**STAFF RECOMMENDATION**  
**1218 Forrest Avenue**  
**February 15, 2017**

**Application:** New construction-detached accessory dwelling unit; Setback determination  
**District:** Lockeland Springs-East End Neighborhood Conservation Zoning Overlay  
**Council District:** 06  
**Map and Parcel Number:** 08309010900  
**Applicant:** Paul John Boulifard  
**Project Lead:** Paul Hoffman, paul.hoffman@nashville.gov

1 ARCHITECTURAL SITEPLAN  
1/16" = 1'-0"

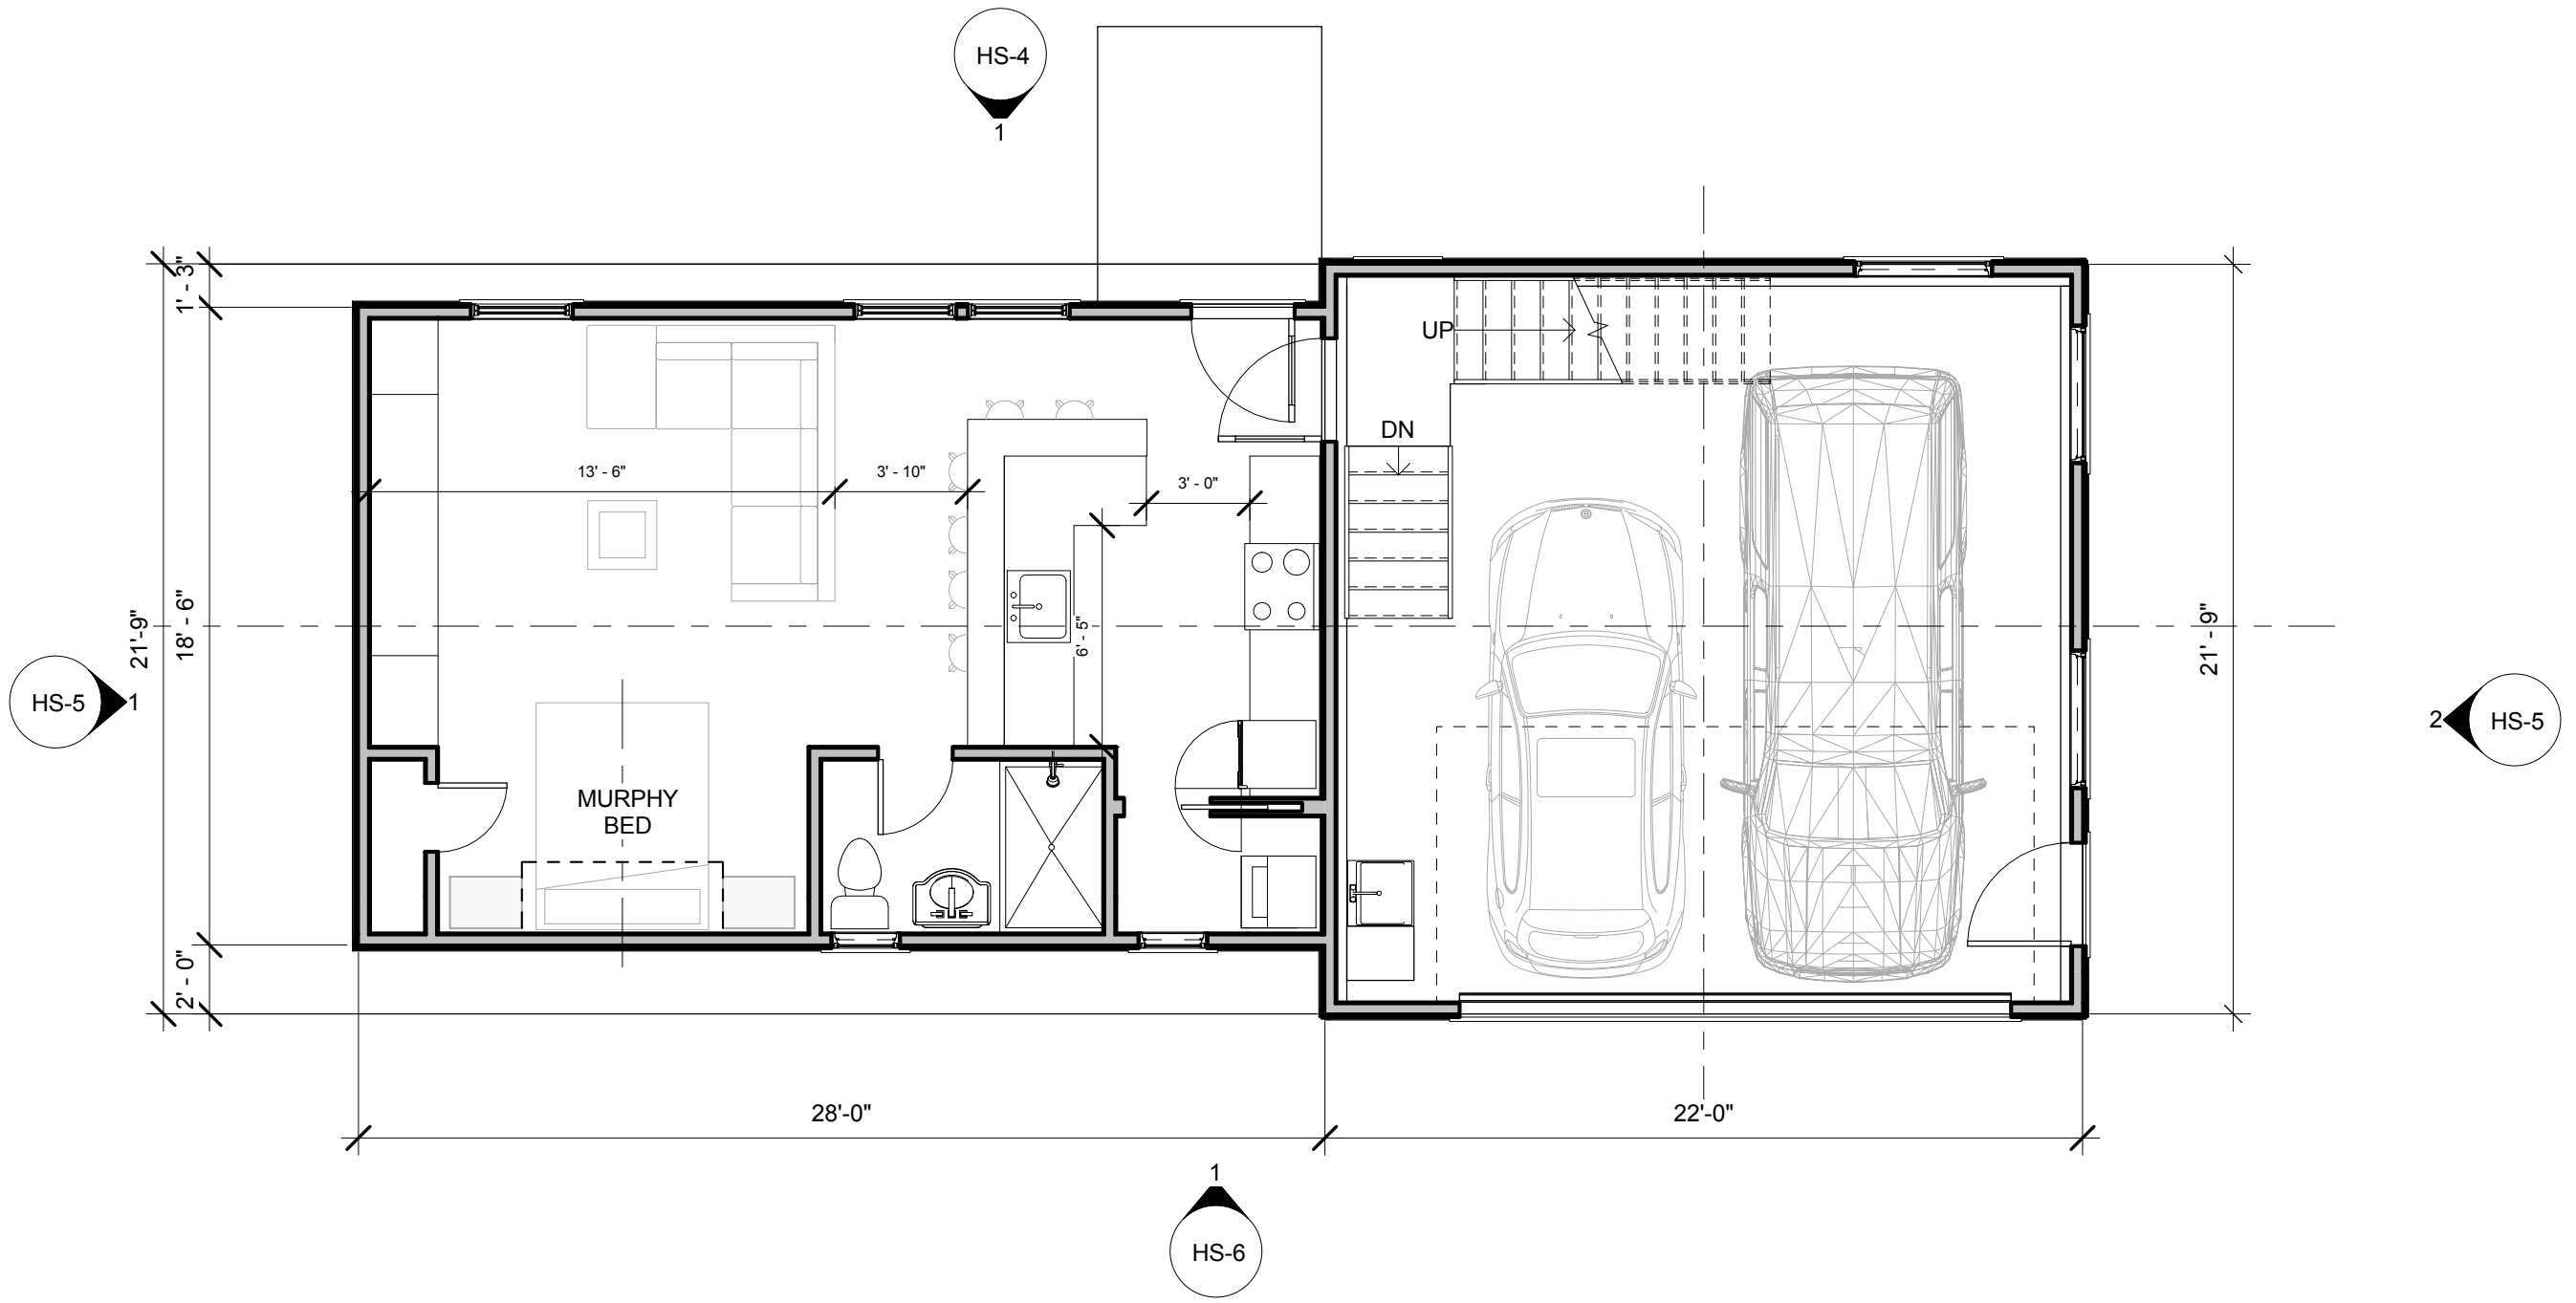
<b>MINIMUM</b>	<b>PROPOSED</b>
<b>Building located towards rear of lot</b>	n/a	Yes
<b>Space between principal building and DADU/Garage</b>	20'	53' 7"
<b>Rear setback</b>	20'	13' 5"
<b>L side setback**</b>	3'	11' 10"
<b>R side setback**</b>	3'	18' 2"
<b>How is the building accessed?</b>	From the alley or existing curb cut	Alley
<b>If the building is two-bay and the vehicular doors face the street, are there two different doors rather than one large door?</b>	Two-bay	Doors face the alley

The new outbuilding requires a rear setback determination. Code requires a structure greater than seven hundred square feet (700 sq. ft.) to be twenty feet (20') from the rear property line. This nine hundred and ninety-seven square foot (997 sq. ft.) outbuilding is proposed at thirteen feet, five inches (13' 5") from the property line. As the location of outbuildings on or near the rear property line is a common occurrence historically, staff finds the location appropriate and recommends approval of the setback determination. The project meets section II.B.h.1 of the design guidelines and 17.16.30.G. 4 of the ordinance.
